UNITED STATES PATENT AND TRADEMARK OFFICE

Office Action Summary

10/762,776

DETAILED ACTION

Leone (US 5,961,242)

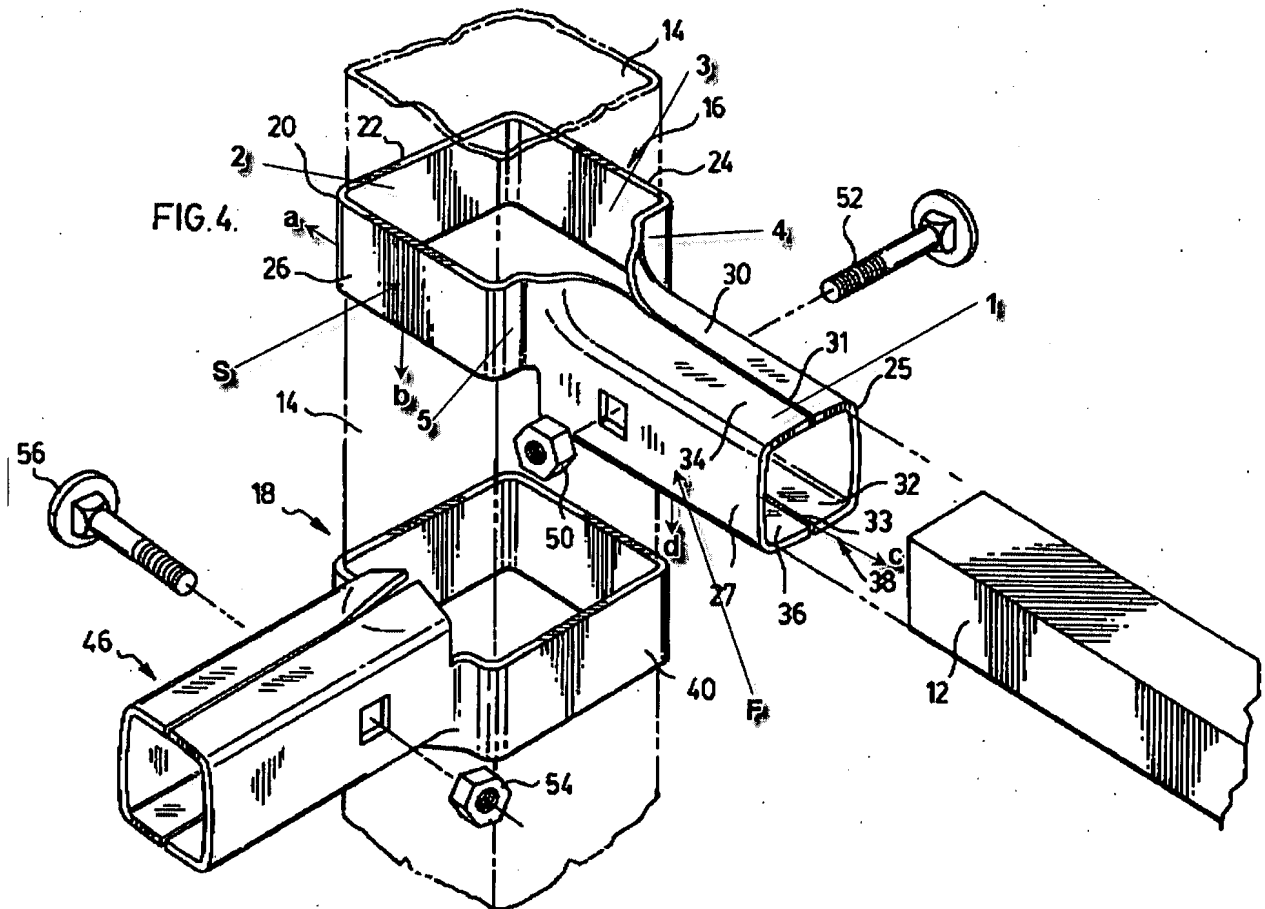
Regarding claim 1, Leone discloses a bracket assembly having first (16) and second (18) cooperating brackets aligned in a confronting relationship and connector means comprising first (52) and second (58) bolts, (Figure 2, annotated Figure 4). The phrase “for interconnecting said first and second cooperating brackets to the first and second elongate structural members and to each other” is considered intended use and is given no patentable weight.

Said first and second bracket each having a generally planar surface having a first portion (F) and second portion (S), said first portion engaging the first elongate structural member (12) and said second portion engaging the second elongate structural member (14); a first wall (1) connected to and extending generally perpendicularly from said first portion of said generally planar surface for engaging the first structural member; a second wall (2) connected to and extending generally perpendicularly from said second portion of said generally planar surface for engaging the second structural member; a third wall (3) connected to and extending generally

perpendicularly from said second wall; and a fourth wall (4) connected to and extending generally perpendicularly from said third wall for engaging the first structural member, (Figure 2, annotated Figure 4).

Regarding claim 4, Leone discloses the bracket assembly including a fifth wall (5) connected to and extending generally perpendicular from said second portion (S) of said generally planar surface for engaging the second structural member, (annotated Figure 4).

Regarding claim 6, Leone discloses the bracket assembly in which each of said first (F) and second (S) portion of said generally planar surfaces of said first and second brackets are generally rectangular in shape, (annotated Figure 4).

Regarding claim 7, Leone discloses the bracket assembly in which each of said first (F) and second (S) portions of said generally planar surfaces has a major axis (a, c) and a minor axis (b, d), said major axis (a) of said second portion (S) extending at an angle with respect to said major axis (c) of said first portion (F), (annotated Figure 4).

Regarding claim 9, Leone discloses the bracket assembly in which said major axis (a) of said second portion (S) extends at an angle of less than ninety degrees with respect to said major axis (c) of said first portion (F), (annotated Figure 4).

Regarding claim 10, Leone discloses a bracket assembly having substantially identical first (16) and second (18) cooperating brackets aligned in a confronting relationship and connector means (52, 58), (Figure 2, annotated Figure 4). The phrase "for interconnecting said first and second cooperating brackets to the first and second

Said first and second bracket each having a generally planar surface having a first portion (F) and second portion (S), said first portion engaging the first elongate structural member (12) and said second portion engaging the second elongate structural member (14); a first wall (1) connected to and extending generally perpendicularly from said first portion of said generally planar surface for engaging the first structural member; a second wall (2) connected to and extending generally perpendicularly from said second portion of said generally planar surface for engaging the second structural member; a third wall (3) connected to and extending generally perpendicularly from said second wall; and a fourth wall (4) connected to and extending generally perpendicularly from said third wall for engaging the first structural member; a fifth wall (5) connected to and extending generally perpendicular from said second portion (S) of said generally planar surface for engaging the second structural member, (annotated Figure 4).

Regarding claim 14, Leone discloses the bracket assembly in which each of said first (F) and second (S) portions of said generally planar surfaces has a major axis (a, c) and a minor axis (b, d), said major axis (a) of said second portion (S) extending at an angle with respect to said major axis (c) of said first portion (F), (annotated Figure 4).

Regarding claim 16, Leone discloses the bracket assembly in which said major axis (a) of said second portion (S) extends at an angle of less than ninety degrees with respect to said major axis (c) of said first portion (F), (annotated Figure 4).
